**Levy Nuclear Plant Units 1 and 2
COL Application
Part 2, Final Safety Analysis Report**

3.7 SEISMIC DESIGN

19.55 SEISMIC MARGIN ANALYSIS

Figure 2.5.2-357 Comparison of PBSRS based on updated EPRI-SOG and CEUS SSC models

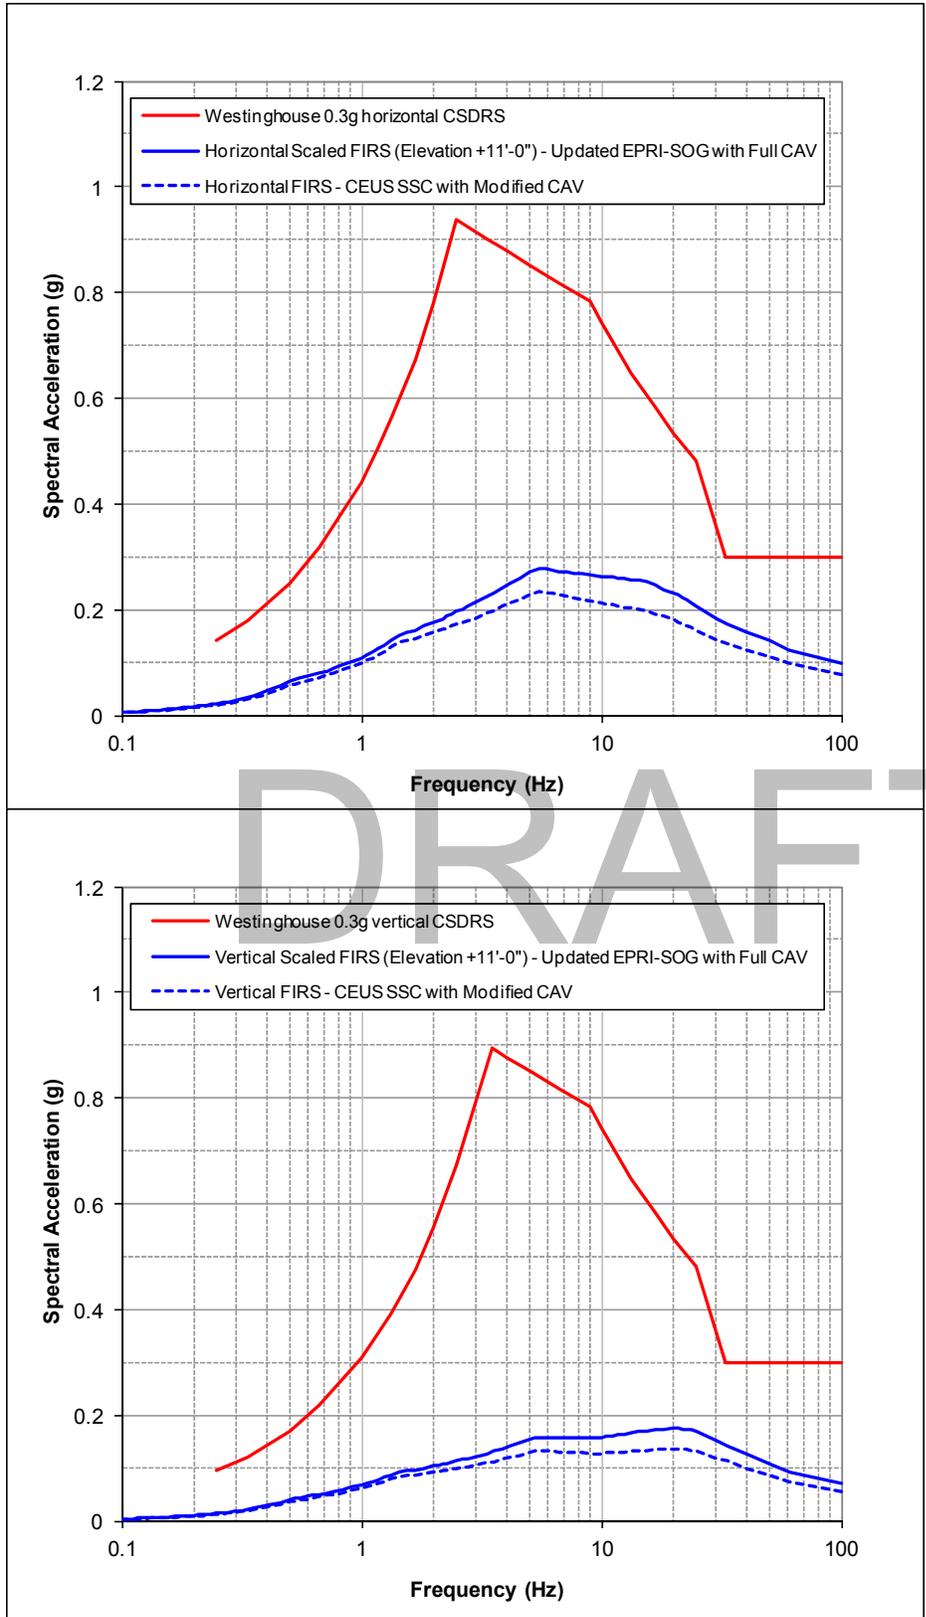
adjacent AB, TB, and RB, earthquake induced cyclic stresses in the soil column were based on ground motions consistent with the finished grade scaled PBSRS. As shown in Figure 2.5.2-357, the CEUS SSC PBSRS is enveloped by the update EPRI SOG scaled PBSRS. Thus, the liquefaction evaluations based on the updated EPRI SOG LNP ground motions bound those from the CEUS SSC ground motions.

As shown in [Figure 2.5.2-357](#), the CEUS SSC PBSRS is enveloped by the updated EPRI SOG scaled PBSRS used for site specific displacement of the Annex Building, Turbine Building, and the Radwaste Building as described in [Subsections 3.7.2.8.1](#), [3.7.2.8.2](#), and [3.7.2.8.3](#). Thus the conclusions in these subsections of no seismic interaction between the Annex Building, Turbine Building, and Radwaste Building and the NI is valid for the LNP site ground motions based on the CEUS SSC model.

Figure 3.7-228

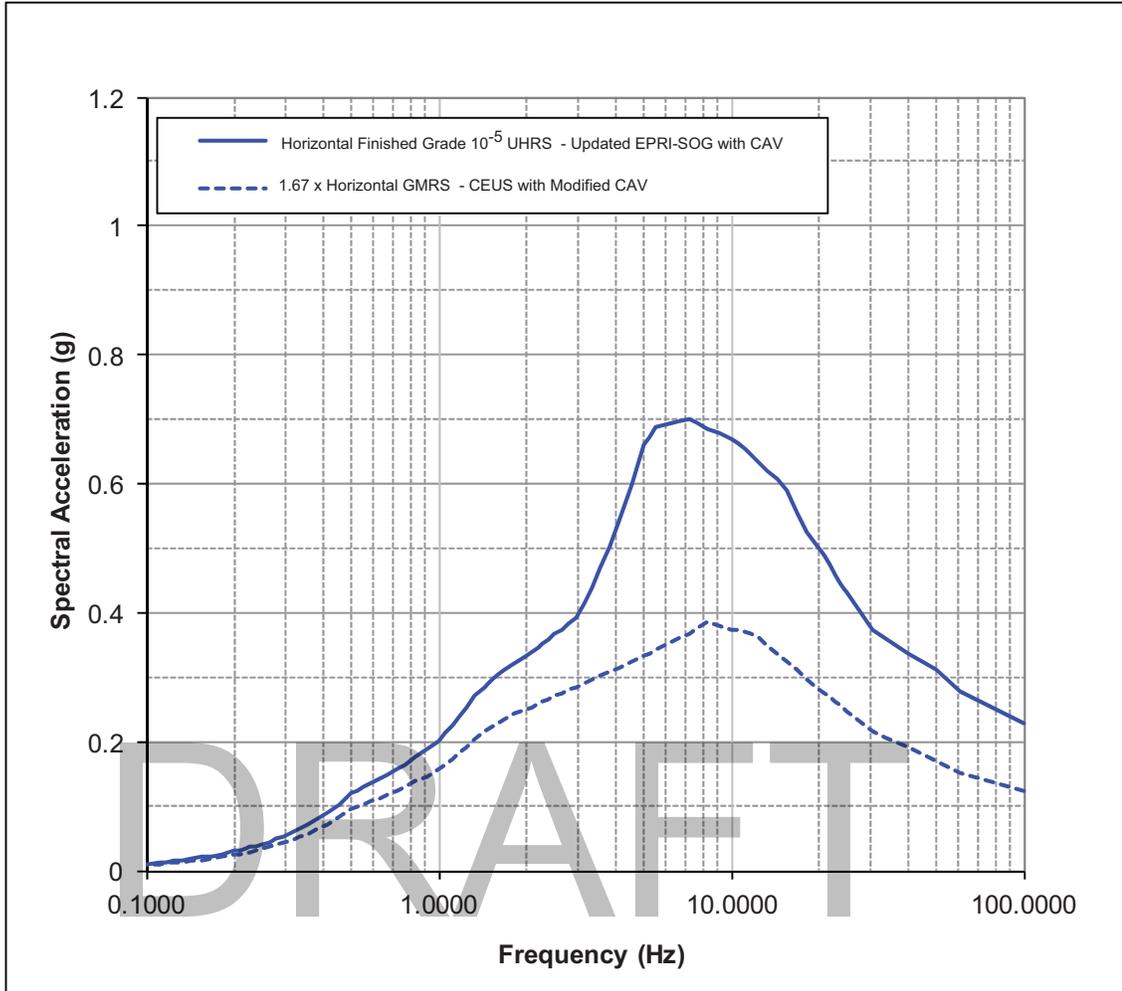
To evaluate the HCLPF liquefaction potential of soils under the adjacent AB, TB, and RB, earthquake induced cyclic stresses in the soil column based on ground motions consistent with the updated EPRI SOG finished grade 10^{-5} UHRS were used. As shown in Figures 3.7-228 and 3.7-229, $1.67 \times \text{GMRS}$ and $1.67 \times \text{PBSRS}$ developed using the CEUS SSC methodology and modified CAV filter are enveloped by the updated EPRI SOG finished grade 10^{-5} UHRS. Thus, HCLPF capacity for no liquefaction potential of soil under the AB, TB, and RB exceeds the $1.67 \times \text{GMRS}$ goal for the plant level HCLPF for the CEUS SSC ground motions.

To evaluate the HCLPF capacity for no seismic interaction between the AB, TB, and RB foundation mats and the NI, the relative displacement between the NI and the AB, TB, and RB foundations was computed based on the updated EPRI SOG 10^{-5} UHRS. As shown in Figures 3.7-228 and 3.7-229, 1.67*GMRS and 1.67*PBSRS developed using the CEUS SSC methodology and modified CAV filter are enveloped by the updated EPRI SOG 10^{-5} UHRS. Thus, HCLPF capacity for no seismic interaction between the AB, TB, and RB foundation mats and the NI exceeds the 1.67*GMRS goal for the plant level HCLPF for the CEUS SSC ground motions.
